Report from the 802.3 Maintenance MAC Interface Adhoc

Jeff Mandin
PMC-Sierra
Sept 2008

Revision #1 (to Figure 4-6)

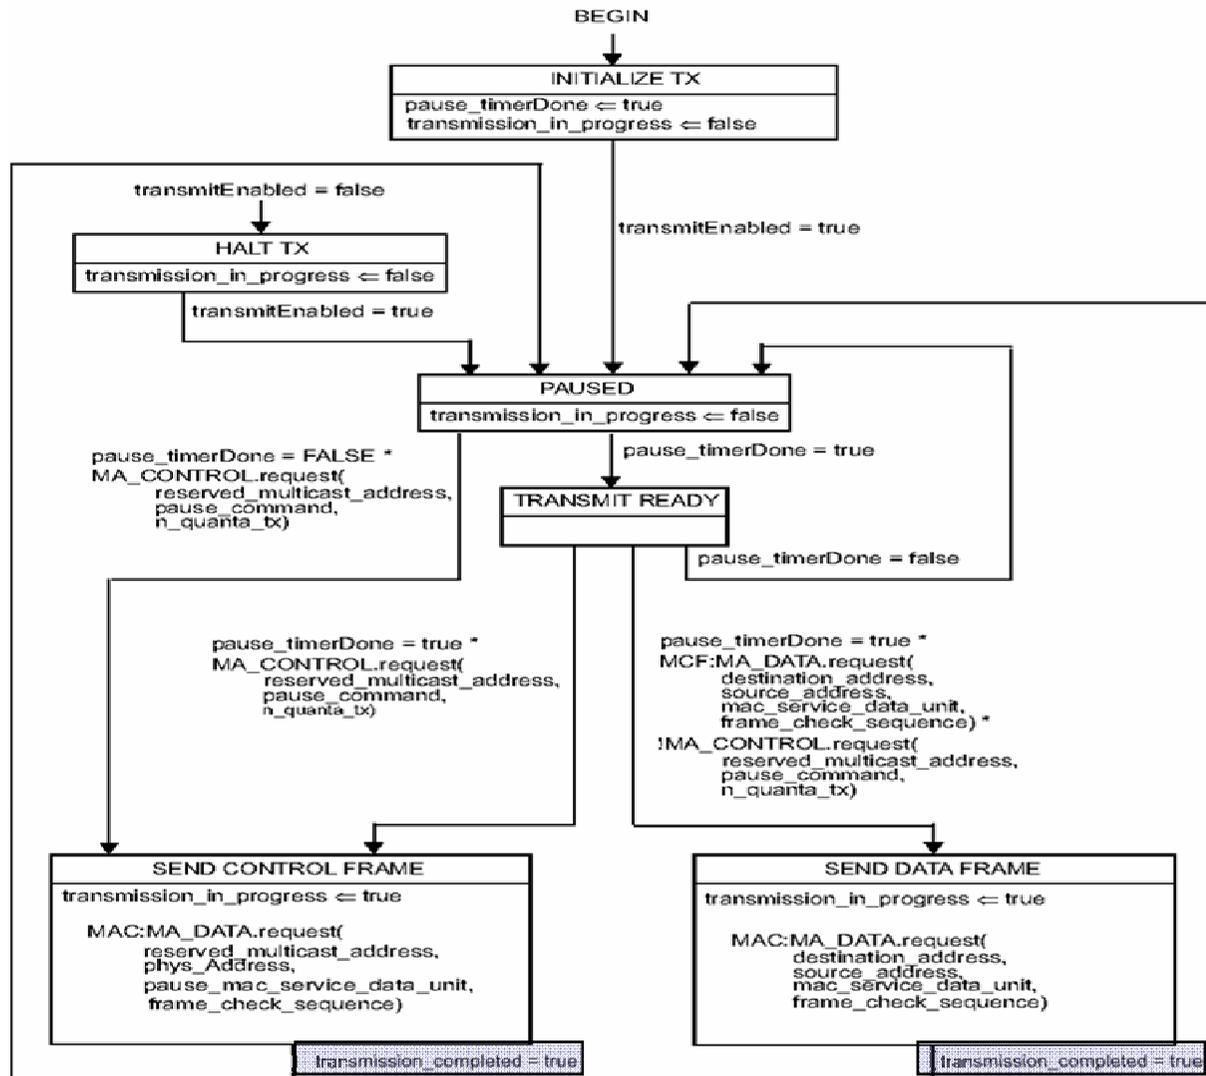
2. Though the intent of figure 4-6 (MAC client transmit interface state diagram) is clear, state diagram conventions in 21.7 are such that its interpretation is not unambiguous.
 - It is necessary to add an exit condition so that it is clear that the process remains in *Generate Transmit Frame* state until the `TransmitFrame` function completes

- Change exit condition from UCT to new variable
TransmitFrameCompleted
- Add new variable to alphabetical list in 4.3.2.1.1 :

TransmitFrameCompleted

Boolean that becomes true when the TransmitFrame function has finished all of its processing

Revision #2 (to Figure 31B-1)

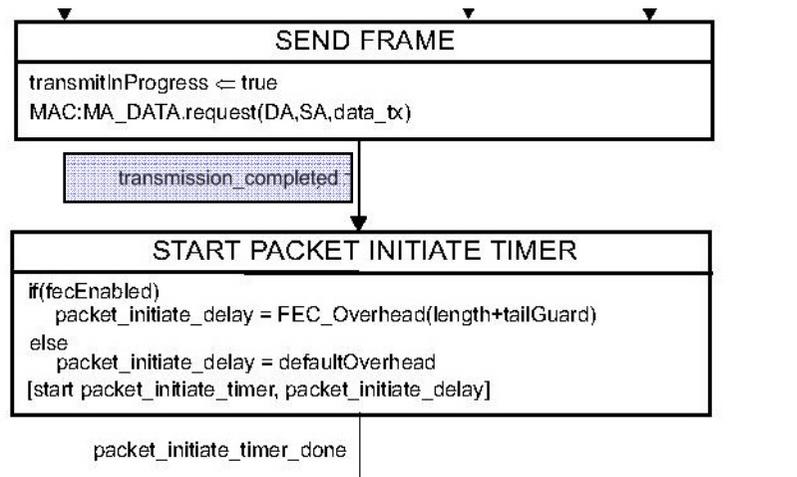
1. Figure 31B-1 (PAUSE transmit state diagram) needs to be modified so that *Send Data Frame* and *Send Control Frame* states are not exited until frame transmission has completed.

a) Change exit conditions from UCT to condition based on new variable *transmission_completed*

b) Add new variable to 31B.3.2.2 :

`transmission_completed`

Boolean that becomes true when the data transmission resulting from the invocation of MAC:MA_DATA.Request is complete

Figure 64-12—OLT Control Multiplexer state diagram

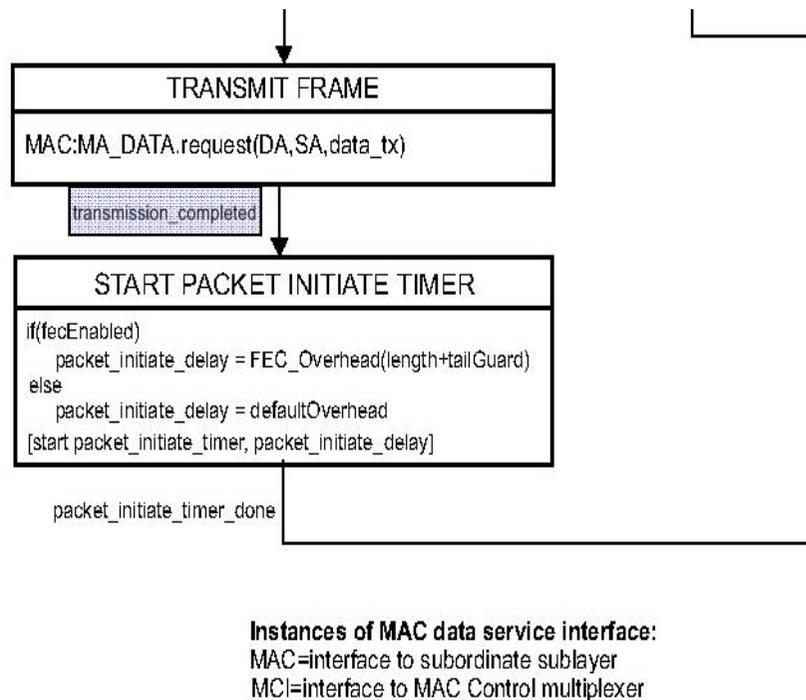
3. As with Figure 31B-1, Figures 64-12 and 64-13 need to be modified so that *Send Frame* And *Transmit Frame* states (respectively) are not exited until frame transmission has completed.
 - The adhoc did not specifically discuss the solution to these diagrams, but assumed that the resolution to PAUSE would apply to them as well

- a) Change exit condition from UCT to new variable *transmission_completed*
- b) Add new variable to alphabetical list in **64.2.2.3** :

transmission_completed

Boolean that becomes true when the data transmission resulting from the invocation of MAC:MA_DATA.Request is complete
